HISTORIC AND DESIGN REVIEW COMMISSION

August 16, 2017

HDRC CASE NO: 2017-396
ADDRESS: 814 BURNET ST
LEGAL DESCRIPTION: NCB 549 (814 BURNET SUB'D {IDZ}), BLOCK 9 LOT 18
CITY COUNCIL DIST.: 2
DISTRICT: Dignowity Hill Historic District
APPLICANT: Felix Ziga/Ziga Architecture Studio
OWNER: Poma Properties, LLC
TYPE OF WORK: Construction of four, two story, single family residential structures
REQUEST:

The applicant is requesting conceptual approval to construct four, two story residential structures on the vacant lot at 814 Burnet.

Poma Properties, LLC
schematic design: setback diagram

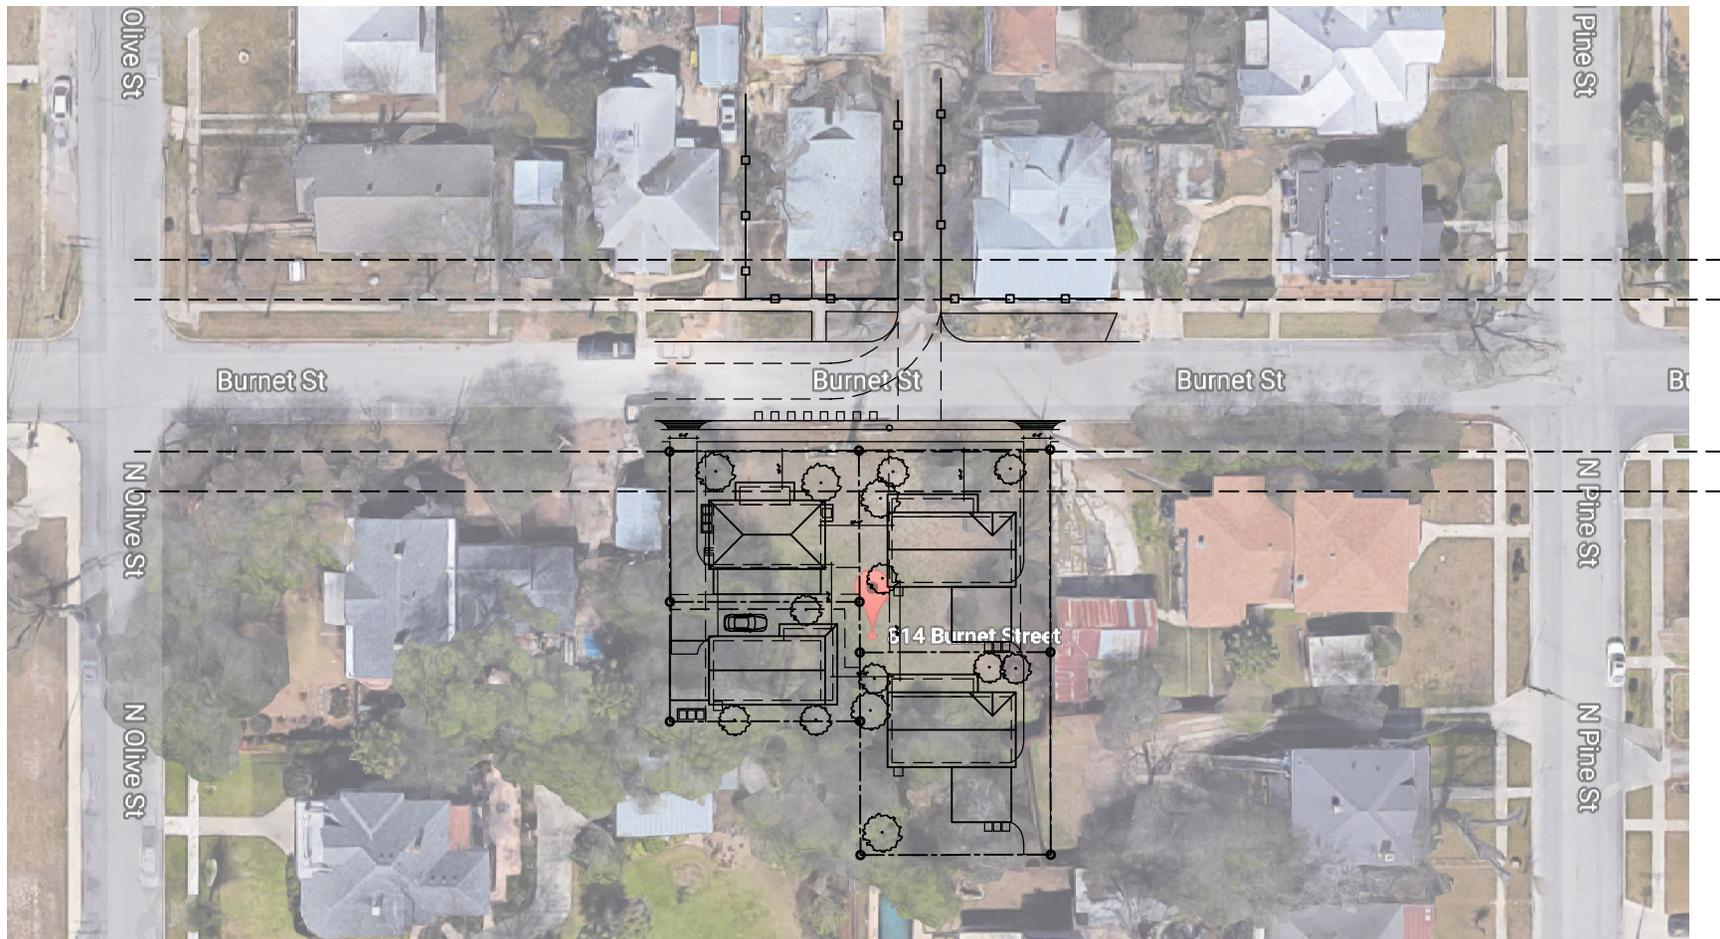
- d. **SETBACKS & ORIENTATION** – According to the Guidelines for New Construction, the front facades of new buildings are to align with front facades of adjacent buildings where a consistent setback has been established along the street frontage. Additionally, the orientation of new construction should be consistent with the historic examples found on the block. Per the applicant’s proposed site plan, two of the residential structures are to address Burnet with setbacks of 12 and 16 feet from the property lines. These two structures would be the only two on Burnet with an orientation toward Burnet. The proposed orientations of units 1 and 2 are appropriate and consistent with the Guidelines. The locations of units 3 and 4 are consistent with those of historic, rear accessory structures. The setbacks of units 1 and 2 should be greater than the side setbacks of both historic structures at the corners of N Pine and N Olive.

schematic design: proposed site / roof plan

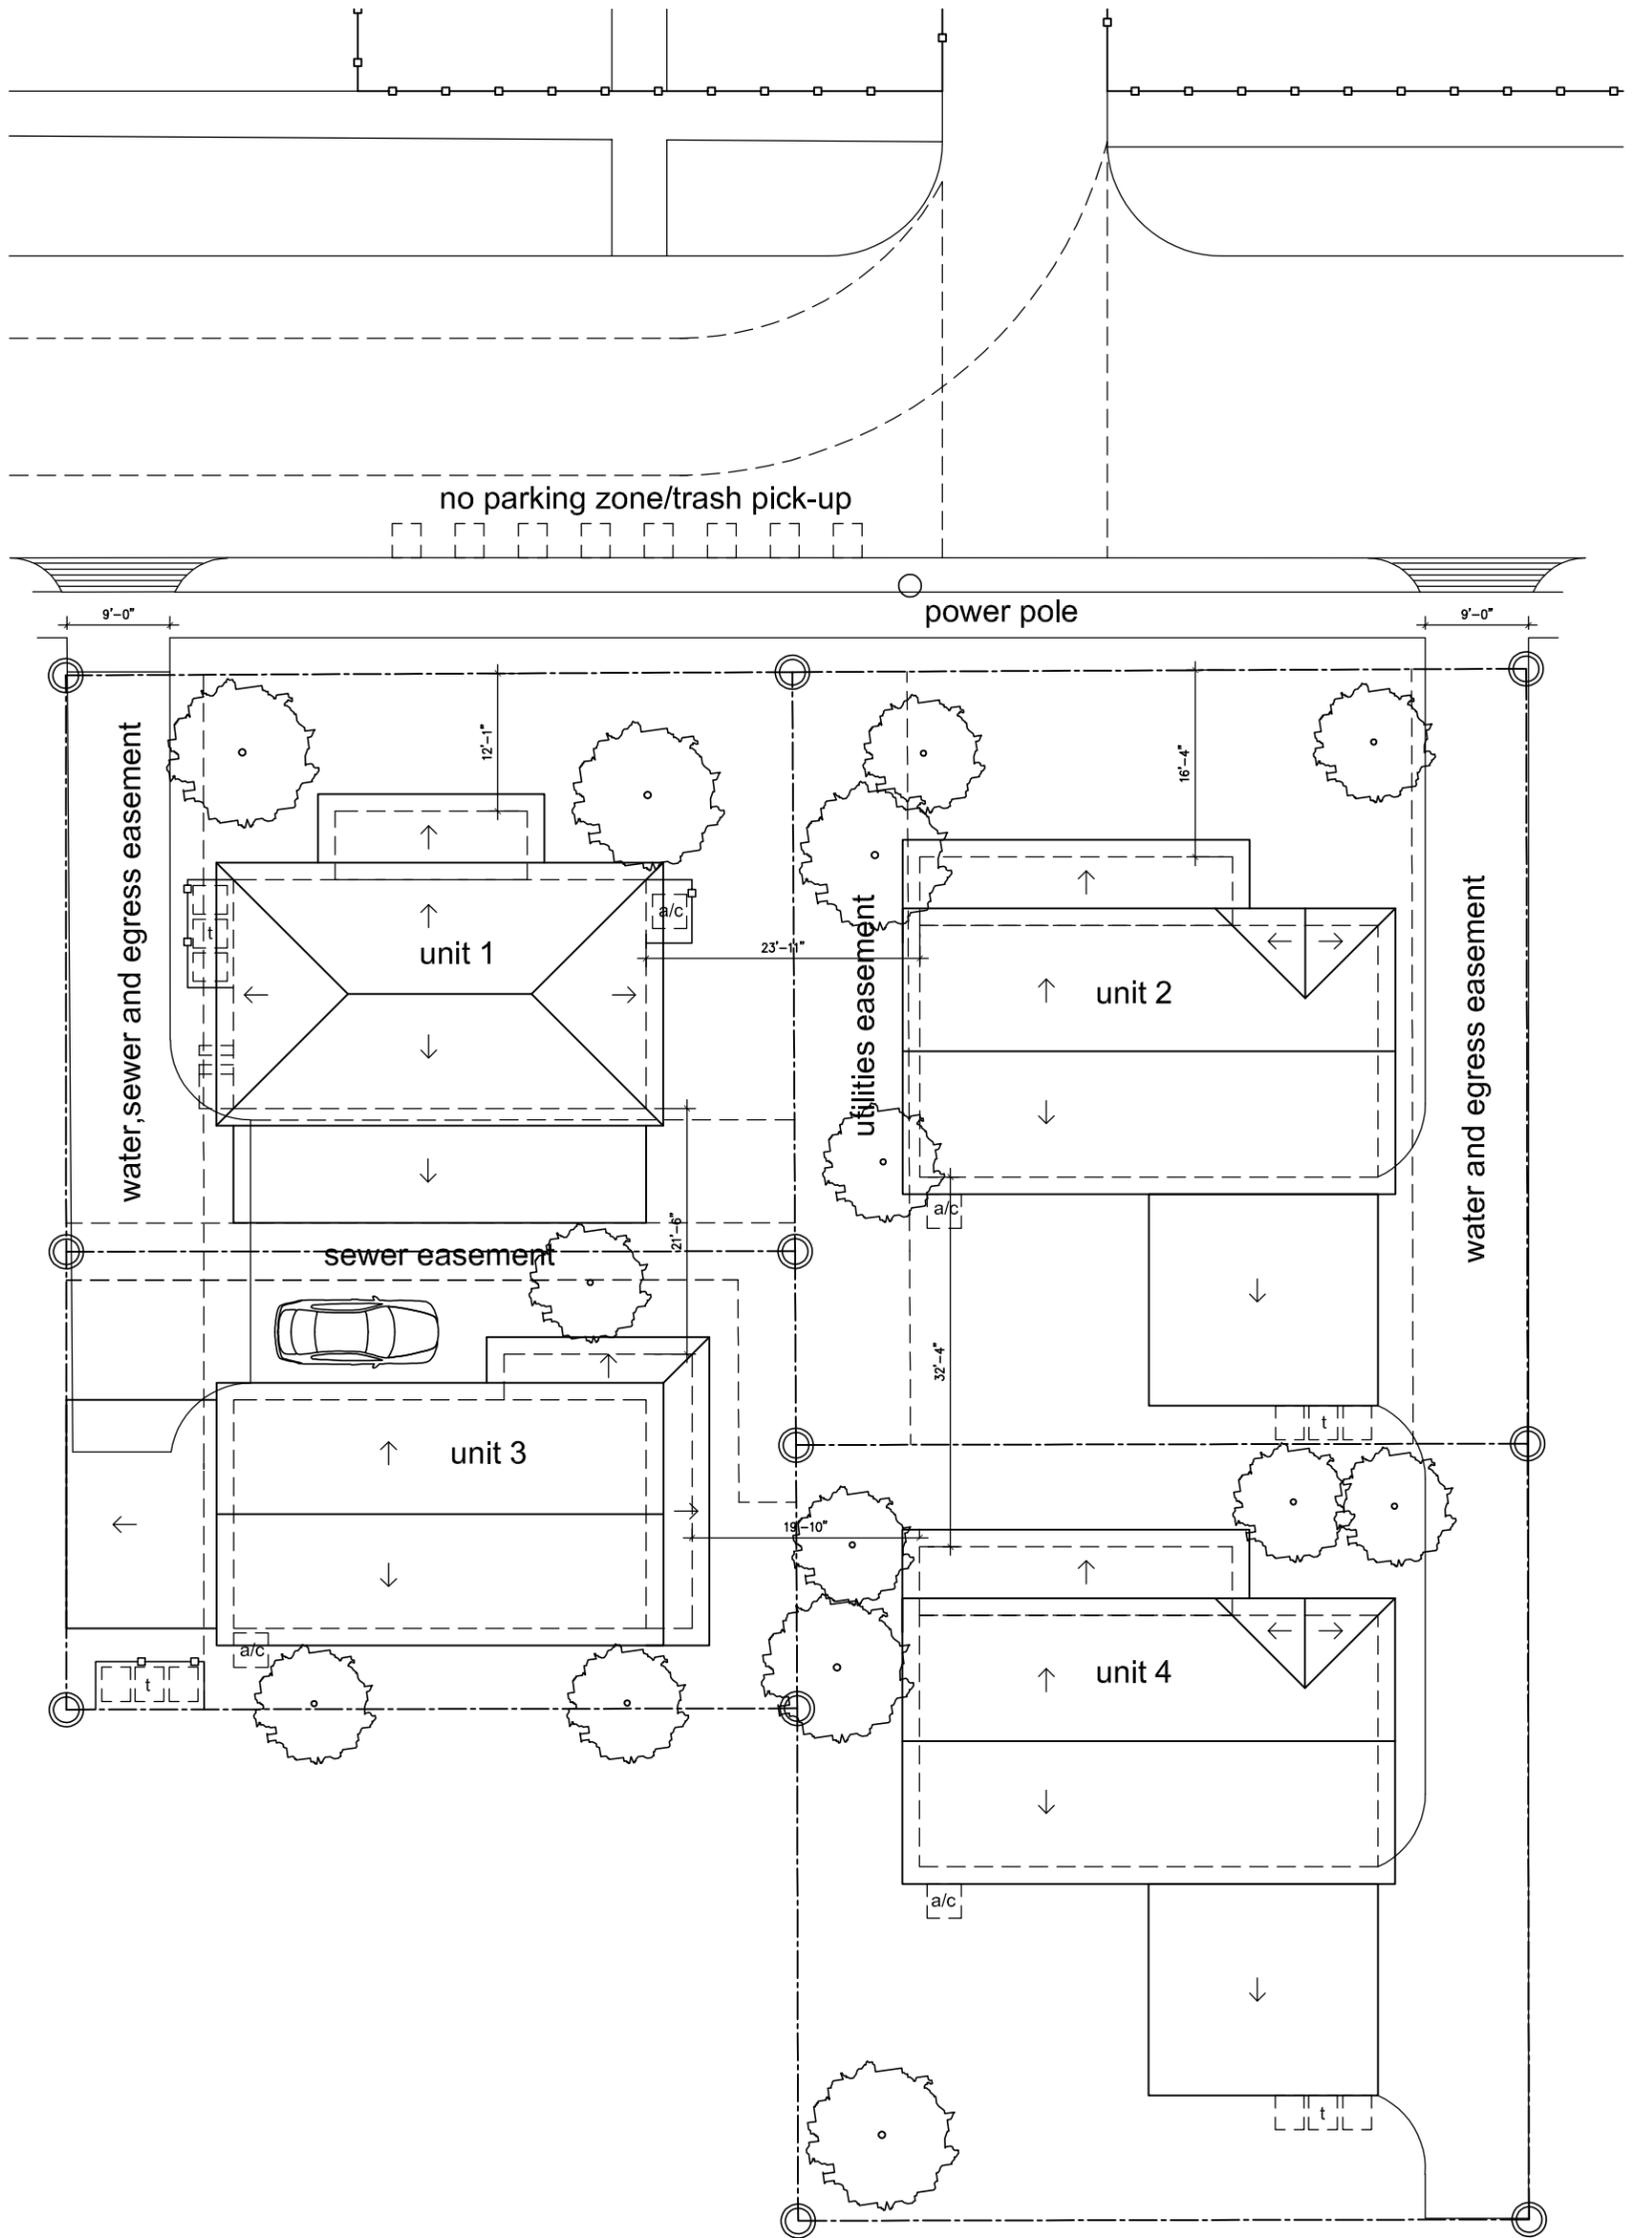
- q. **SIDEWALK** – The applicant has noted the installation of a front yard sidewalk for units 1 and 2; however, has not included these on the site plan. The proposed sidewalks should relate to those found historically in the district in terms of location, width and material and should be centered on the front porch of units 1 and 2.

- r. **DRIVEWAY** – On both the east and west sides of the lots, the applicant has proposed to install driveways to feature nine (9) feet in width. The Guidelines for Site Elements note that driveways should relate to historic driveways in the district and should not exceed (10) feet in width. The proposed driveways are consistent with the Guidelines. Staff finds the installation of two separate driveways located consistently with the pattern within the district is appropriate.

- t. **LANDSCAPING** – The applicant has noted the location of trees and driveways on the site plan; however, a detailed landscaping plan should be submitted to staff prior to submitting for final approval.

schematic design: proposed elevations - unit 1

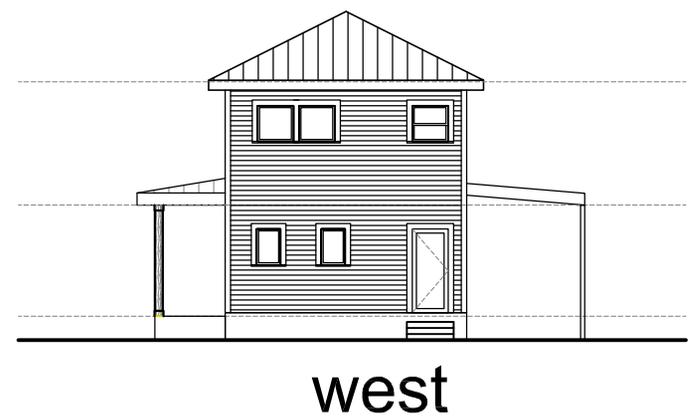
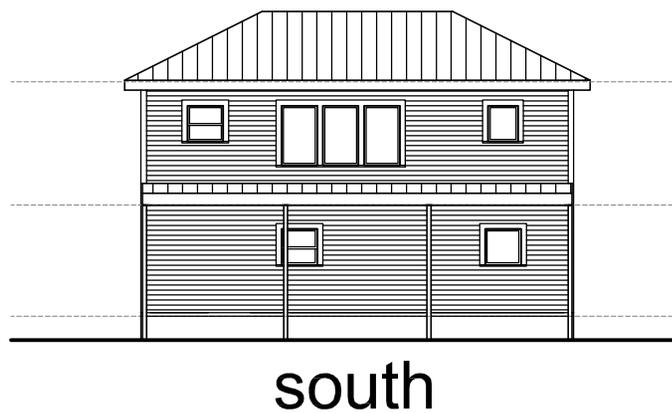
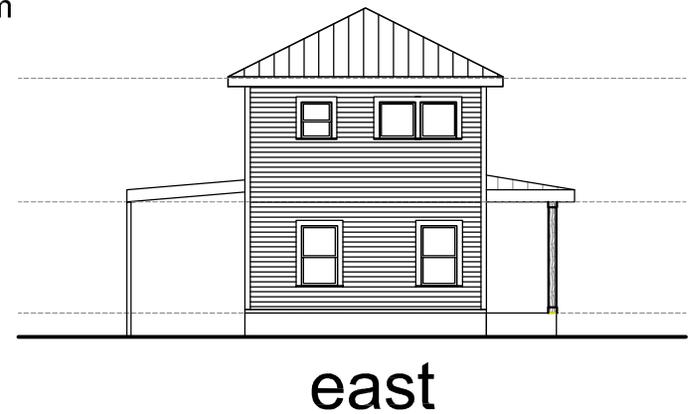
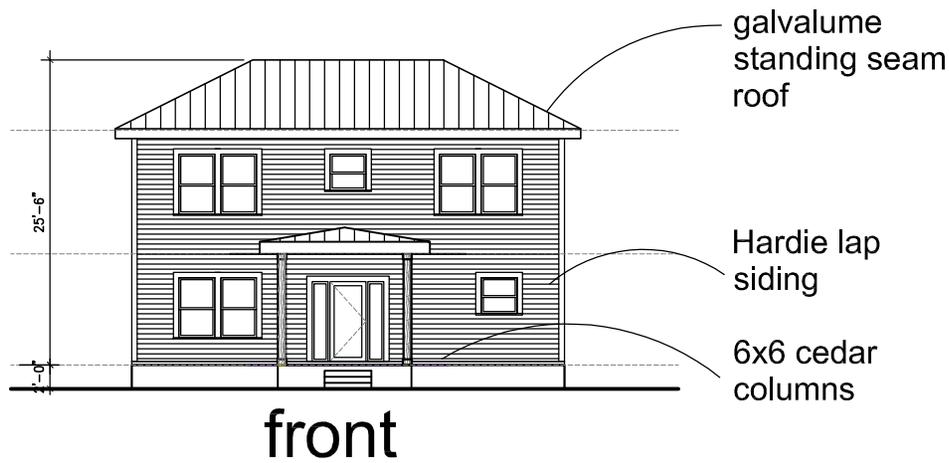
- i. **ROOF FORM** – The applicant has proposed for unit 1 to feature a hipped roof, unit 2 to feature a front and side gabled roof, unit 3 to feature a side gabled roof and unit four to feature a front and side gabled roof, matching that of unit 2. Gabled and hipped roofs are found throughout the Dignowity Hill Historic District; however, many feature more detailed or complex roof form that what is found in the current proposal.

- j. **WINDOW & DOOR OPENINGS** – Per the Guidelines for New Construction 2.C.i. window and door openings with similar proportions of wall to window space as typical with nearby historic facades should be incorporated into new construction. The applicant has proposed window and door openings that lack the amount of fenestration typically found on historic structures. The overall ration of solids to voids should relate to those found on neighboring historic structures and should be consistent with the Guidelines.

- m. **ARCHITECTURAL DETAILS** – New buildings should be designed to reflect their time while representing the historic context of the district. Additionally, architectural details should be complementary in nature and should not detract from nearby historic structures. Architectural details, such as well-proportioned porch elements,

window coverings, roof eaves, and variations in wall planes add depth and visual interest and contribute to the overall quality of the design. Staff finds that as proposed, the structures lack adequate architectural details for compatibility within the historic district.
